Atari Technical Bulletin
Number: TT30-0005
Date: April 2, 1992
Page 1 of 2

Product(s) Affected: TT030
Model: All
Type of ATB: As Needed
ECO #: 1428

To reduce noise and jitter seen on the high resolution monitor.

Figure 1

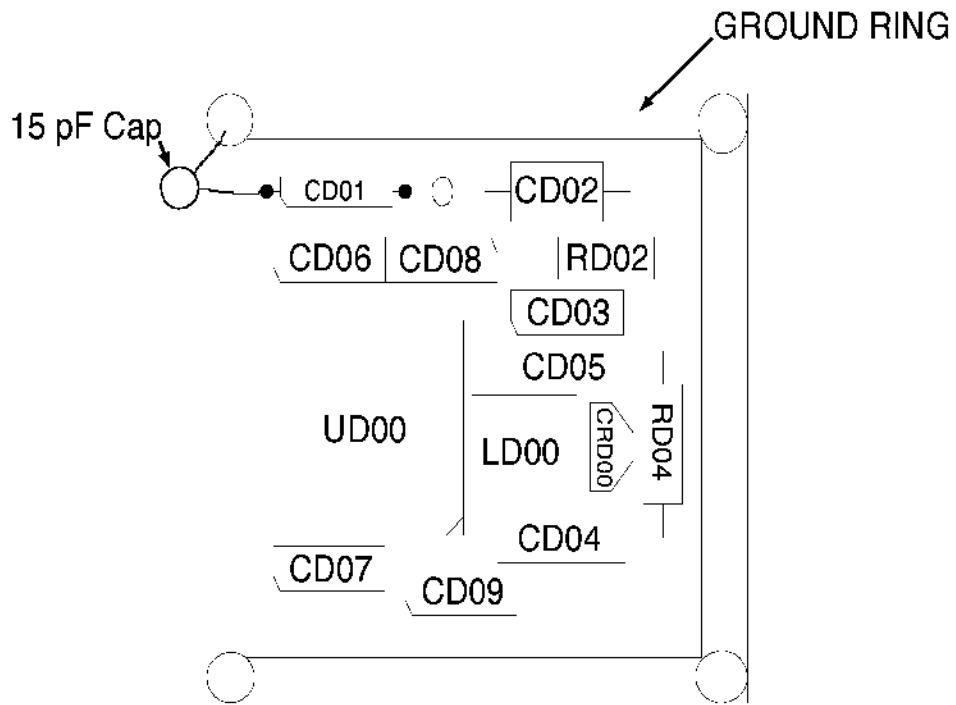
Video jitter on high resolution TT Monitor.

1. Remove the top cover of the TT030.
2. Remove the VME Card Guide.
3. Locate the 8530 circuit. See Figure 1 on page 2.
4. Connect a 15pF capacitor from the left side of CD01 to the top left corner of the ground ring. See Figure 1 on page 2.
5. Re-assemble the unit.
